UNITED STATES PATENT AND TRADEMARK OFFICE

APPLICATION NO.	FILING DATE	FIRST NAMED INVENTOR	ATTORNEY DOCKET NO.	CONFIRMATION NO.
09/986,956	11/13/2001	Manuel Barbosa	1356-041	6385
25215 7590 08/21/2007 DOBRUSIN & THENNISCH PC 29 W LAWRENCE ST SUITE 210 PONTIAC, MI 48342			EXAMINER NGUYEN, XUAN LAN T	
			ART UNIT 3683	PAPER NUMBER
			MAIL DATE 08/21/2007	DELIVERY MODE PAPER

Office Action Summary

DETAILED ACTION

FIG 1

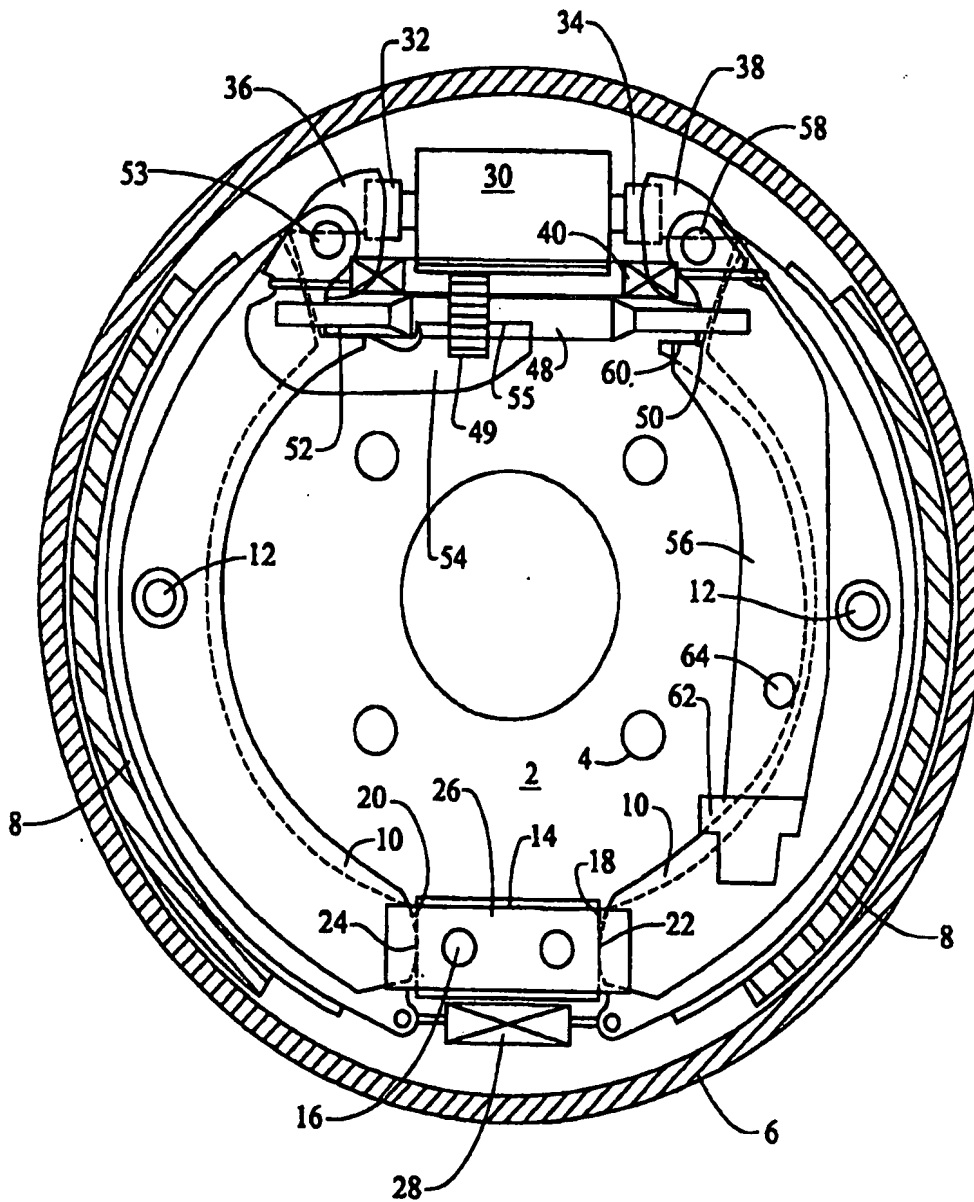
1. The drawings were received on 6/29/07. These drawings are not approved.
2. The drawings are further objected to under 37 CFR 1.83(a). The drawings must show every feature of the invention specified in the claims. Therefore, the claimed feature "a first spring for connecting the lower portion of the first and second brake shoes for maintaining contact of the first and second brake shoes against the surface of the lower actuating block" in claims 24 and 26 must be shown or the feature(s) canceled from the claim(s). No new matter should be entered. Please note page 4 of the specification, paragraph 16 where it states "A spring 28 is connected between the ends of the levers to hold ends 22 and 24 to surfaces 18 and 20."

NOT
approved
8/14/07
XLN

Corrected drawing sheets in compliance with 37 CFR 1.121(d) are required in reply to the Office action to avoid abandonment of the application. Any amended replacement drawing sheet should include all of the figures appearing on the immediate prior version of the sheet, even if only one figure is being amended. The figure or figure number of an amended drawing should not be labeled as "amended." If a drawing figure is to be canceled, the appropriate figure must be removed from the replacement sheet, and where necessary, the remaining figures must be renumbered and appropriate changes made to the brief description of the several views of the drawings for consistency. Additional replacement sheets may be necessary to show the renumbering of the remaining figures. Each drawing sheet submitted after the filing date of an

FIG. 2

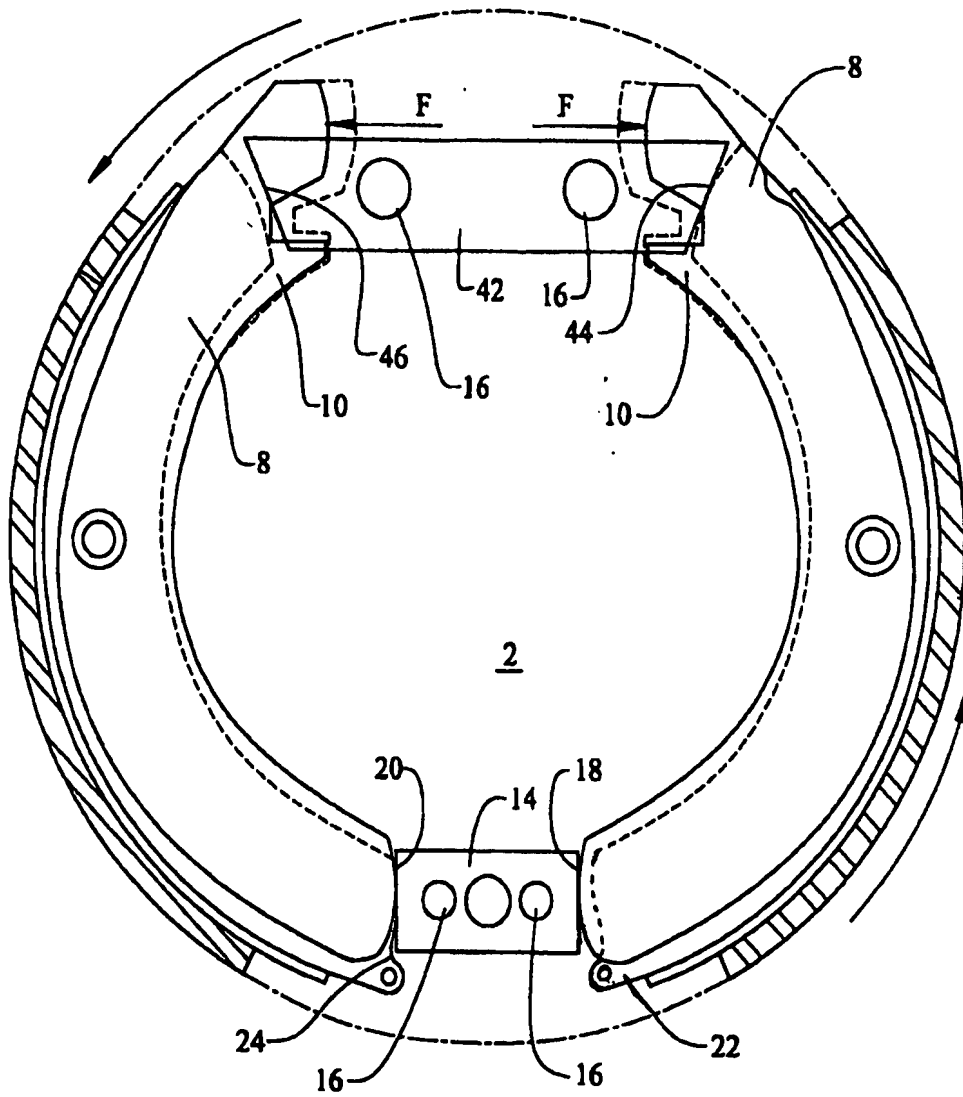
NOT
approved
XLW
8/14/07
